SONGS-1 SEISMIC PROGRAM FOR LONG TERM SERVICE

Responses to Action Items Resulting
From the 02/12/85 and 02/27/85
Meetings with the NRC.

SOUTHERN CALIFORNIA EDISON COMPANY

March 11, 1985

FIGURE 1

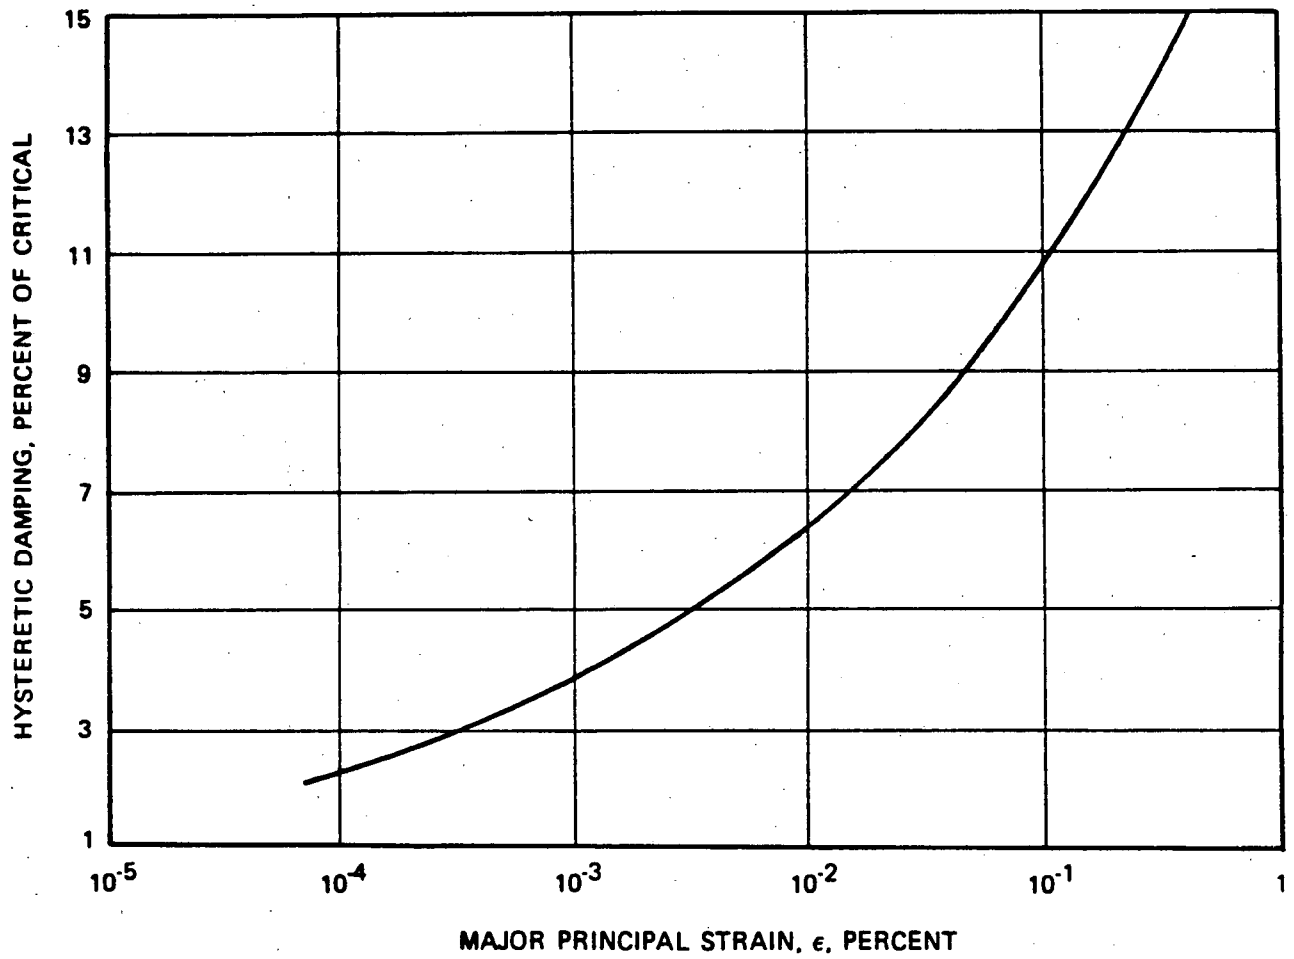
ACTION ITEM 23: Provide justification for the 11 percent damping value used for soil material in the SSI.

The damping-strain relationship (shown in Figure 1) for the San Mateo sand at the SONGS site was developed by Woodward-McNeill & Associates (Reference 1). The soil material (hysteretic) damping was measured by cyclic triaxial testing in the laboratory and by field attenuation tests performed at the site.

For the 0.67g Modified Housner event, major principal soil strains are expected to be on the order of .2 percent (Reference 2). As seen from Figure 1, this corresponds to soil material damping of approximately 12 percent. Per Impell's long-term criteria document (Reference 3), soil material hysteretic damping will be limited to the damping value at 0.1 percent soil strain, which corresponds to 11 percent soil damping from Figure 1. This approach is justified because of the inherent conservatism it provides to any soil-structure interaction analysis.
